PLANNING TECHNICAL REVIEW COMMITTEE –AGENDA

Re: Dover Heights (P-19-15)
Redevelopment of 1 First Street, Dover, NH
Technical Review Committee Minutes, Site Plan Review, March 7, 2019
KNA Project No. 17-1219-1

RESIDENTIAL SITE PLAN

DOVER HEIGHTS

FIRST FLOOR
1/16" = 1'-0"
(GRADE LEVEL ON SECOND STREET)

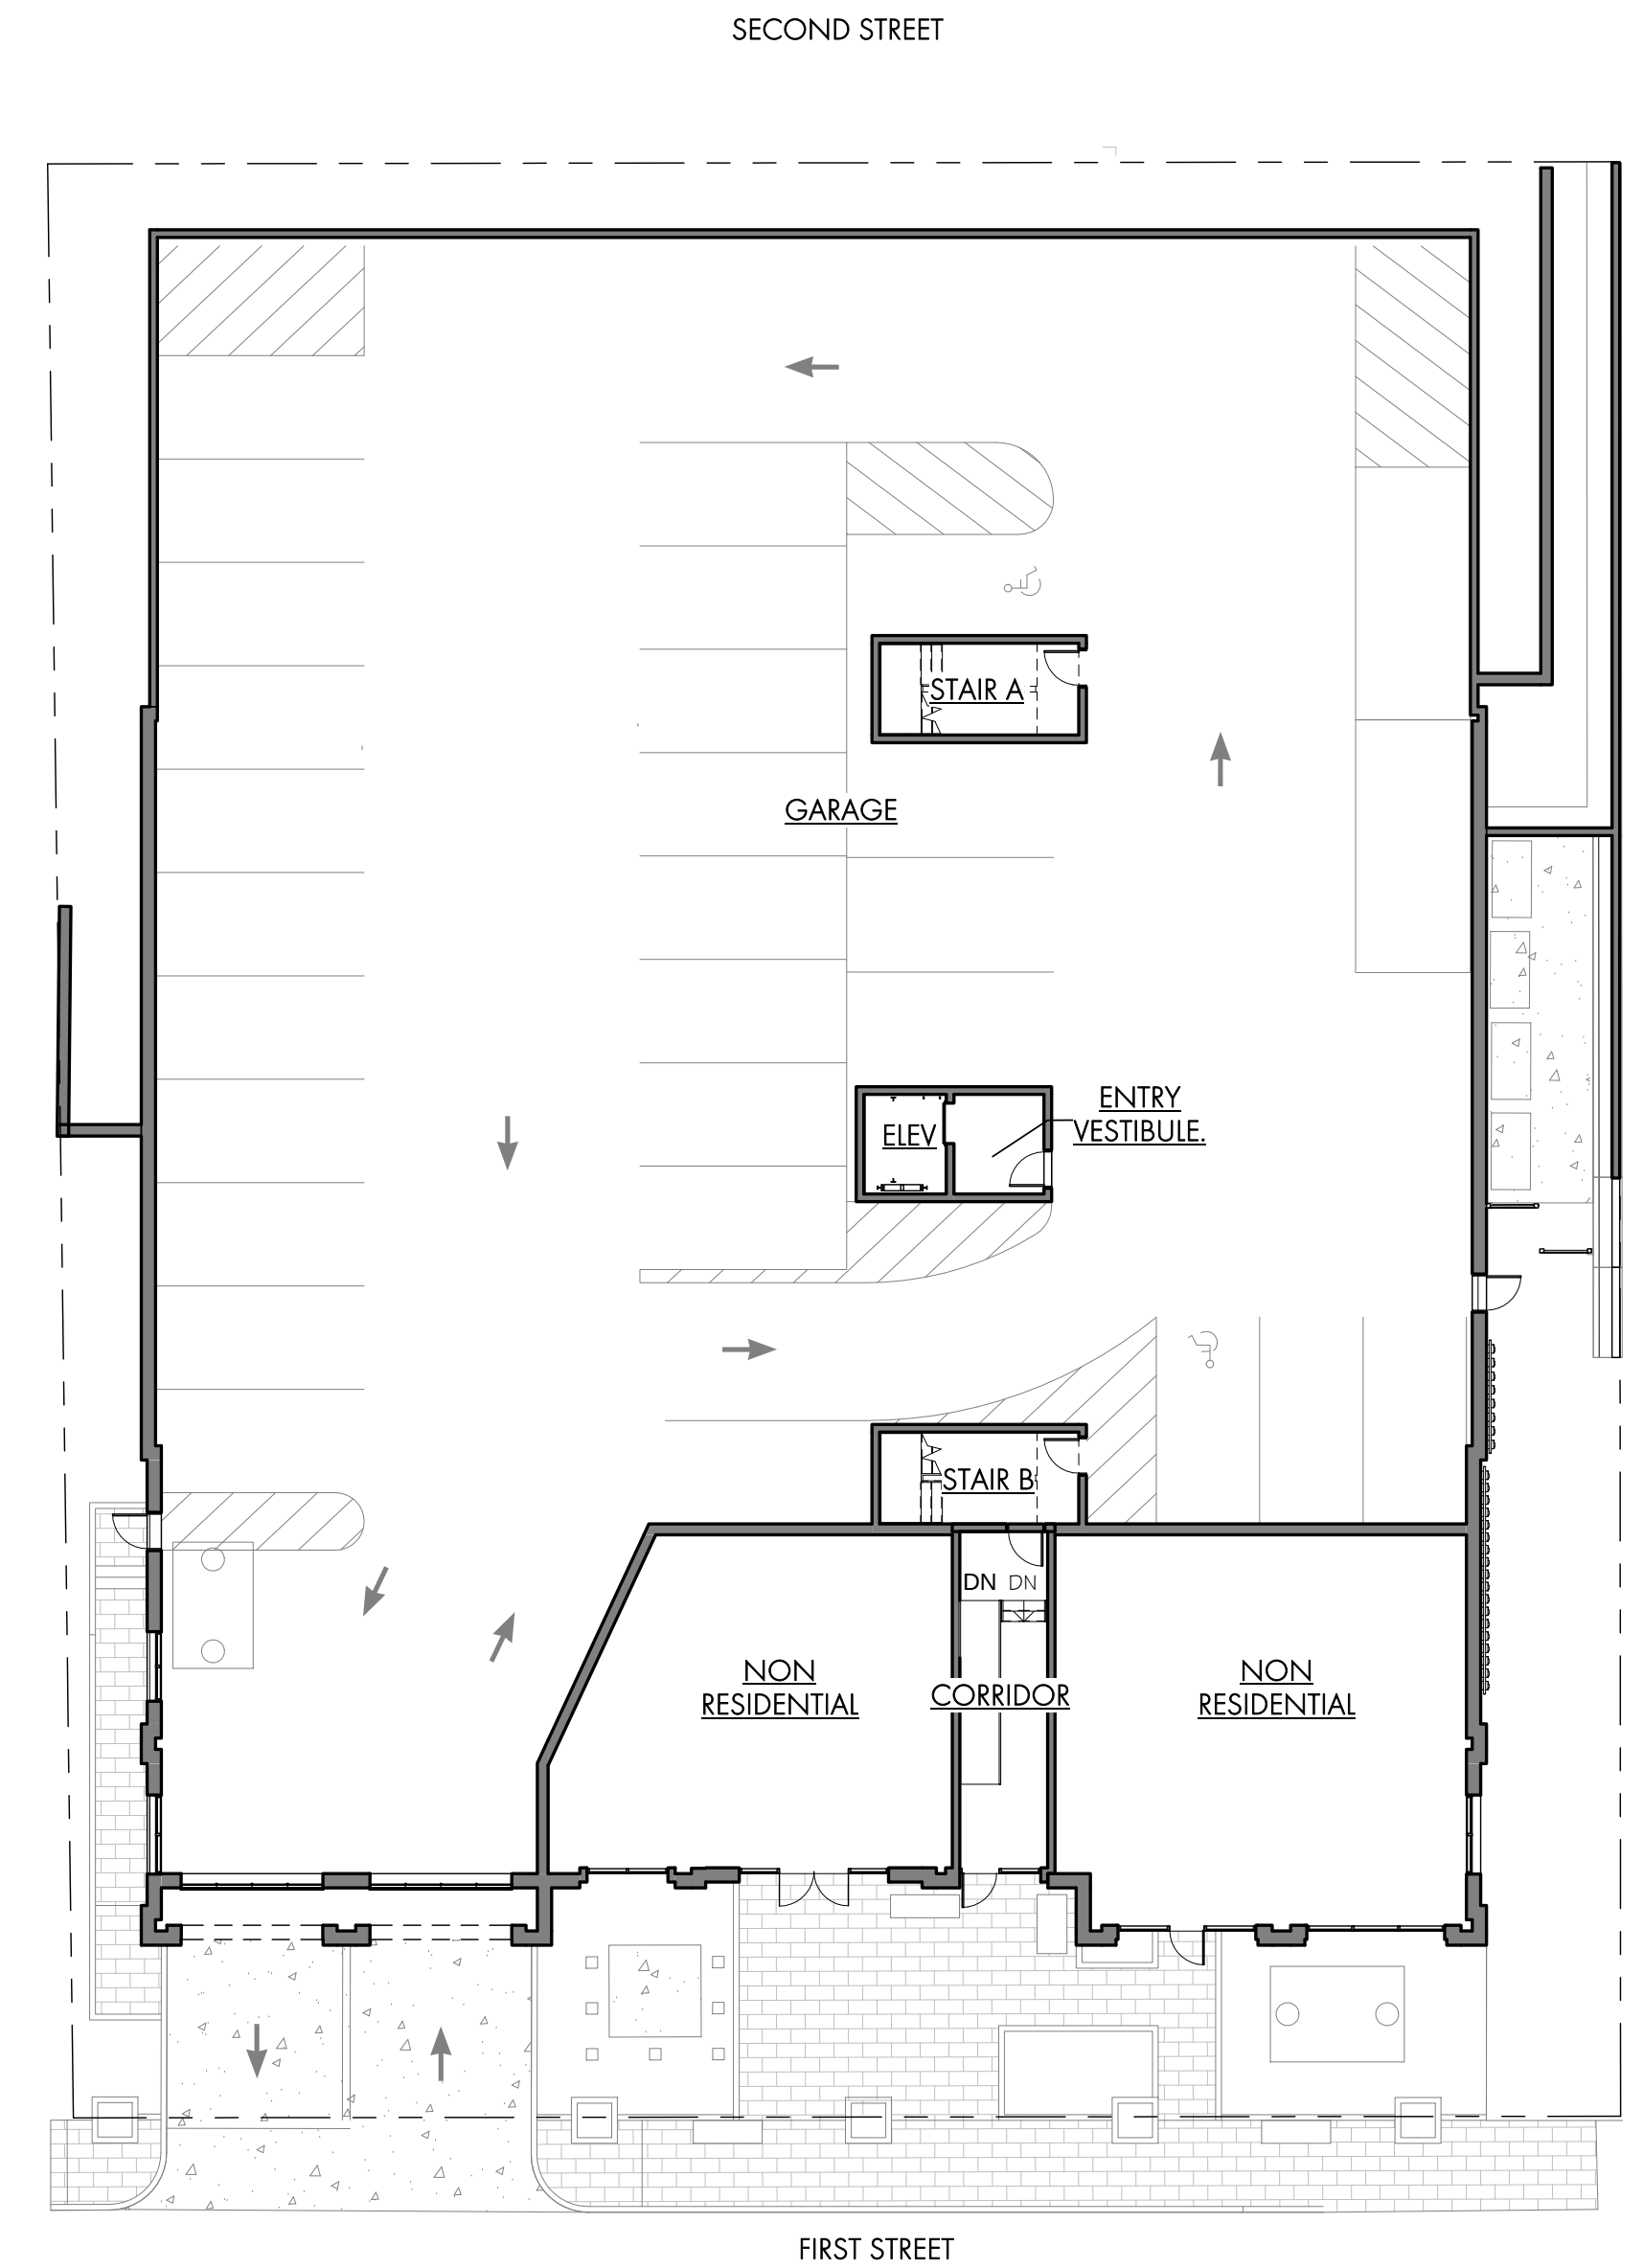
- The Landscape Plan (sheet 8) legend was updated.*
- i. Correct floor numbers on floor plan.
- The floor plans have been revised.*
- j. Indicate materials on building elevations.
